Planning and Zoning:	5/3/2021	Staff Contact:	Ian Beck, Planner I
Agenda Item:	2021-0456	E-mail:	ianb@pflugervilletx.gov
Case No.	ARB2104-01	Phone:	512-990-6303

SUBJECT: Discuss and consider an application for a Landscape Architectural Waiver Request to reduce the minimum tree planting requirements for a multi-family development pursuant to Subchapter 11 Table 11.3 C, of the Unified Development Code for the 19365 Wilke Lane multi-family project. (ARB2104-01).

EXHIBIT A (Standard)

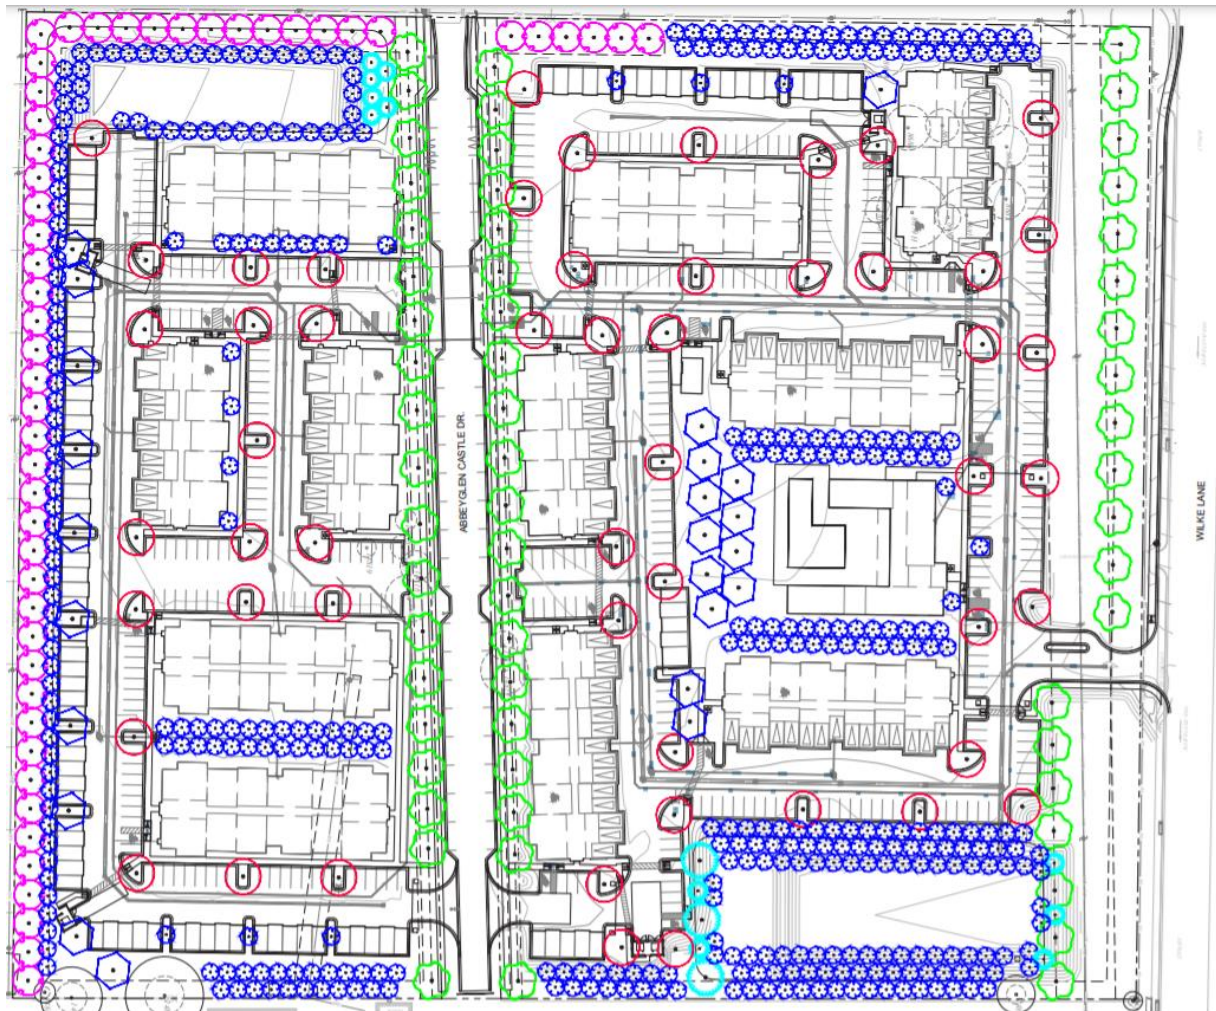
Based on spacing all proposed trees of mature canopy sizes, meeting the minimum number of caliper inches is not achievable at a 1:300 ratio.

EXHIBIT B (Standard +)

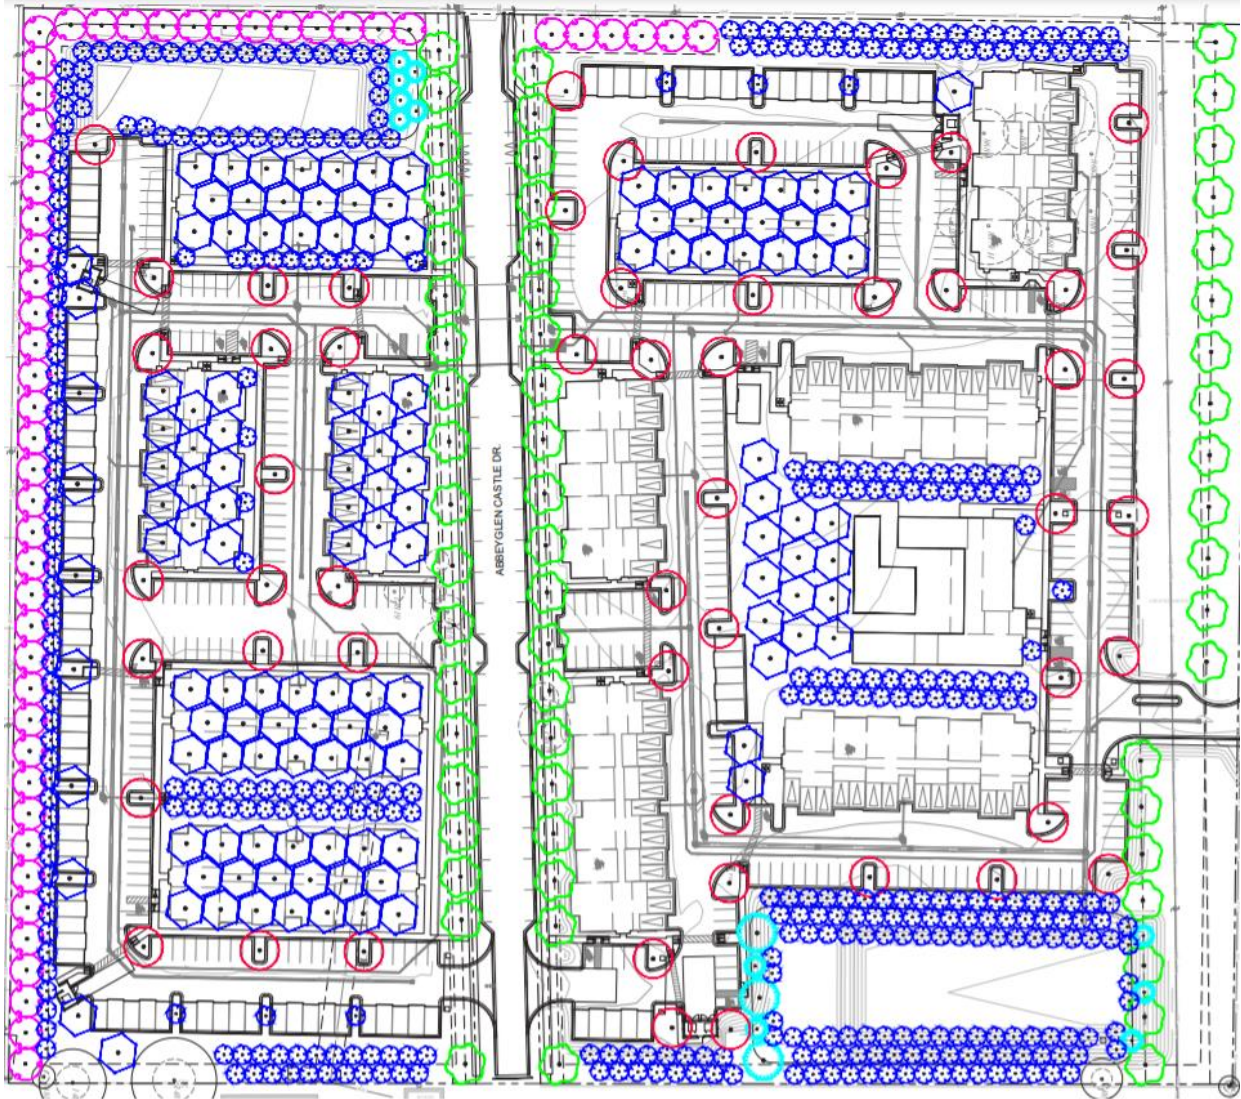
Based on spacing all proposed trees at mature canopy sizes, meeting the minimum number of caliper inches is only achievable at a 1:300 ratio if at least six (6) of the eleven (11) buildings are removed. By doing this, the overall density of the site would no longer be achievable.

As an additional illustration of the site impacts from UDC Section 11.3, please reference the enclosed Exhibit B. The exhibit revises the current site plan to accommodate an additional 213 trees onsite to meet the landscape tree requirement of 751 trees outlined in Column B of Figure A. Instead of a dense urban development which is envisioned for properties with the CL-5 Urban Center zoning designation, the City of Pflugerville would receive an undersized multifamily development and a dense forest of trees.

EXHIBIT C (Proposed)

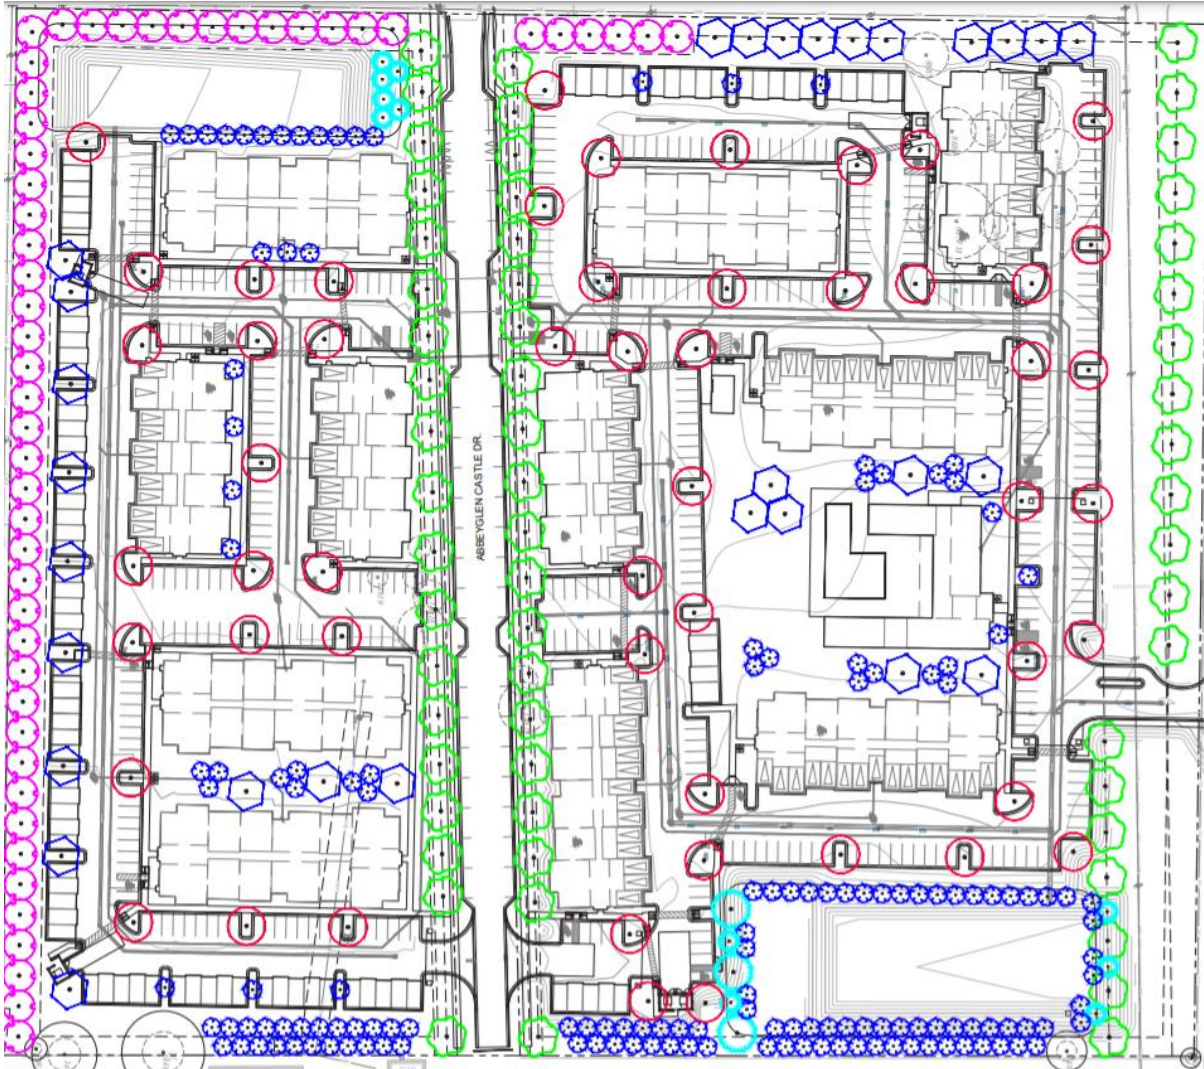
While utilizing the above adjustments, meeting all the landscape requirements is achievable at a 1:600 ratio.

As shown on the proposed site plan in Exhibit C, should this waiver request be approved Cerco can meet the additional code requirements outlined in UDC Subchapter 11 and would also pay over \$100,000 into the City of Pflugerville's tree mitigation fund.

Staff recommends adjusting the landscape tree ratio from 1:300sf to 1:600sf as provided in Scenario C to ensure the health of the trees. The adjustment does not change the minimum number of shrub, street trees, bufferyard or detention pond plantings and will maintain the general intent of the Unified Development Code. If the Commission should choose an alternative, conditions may be imposed.
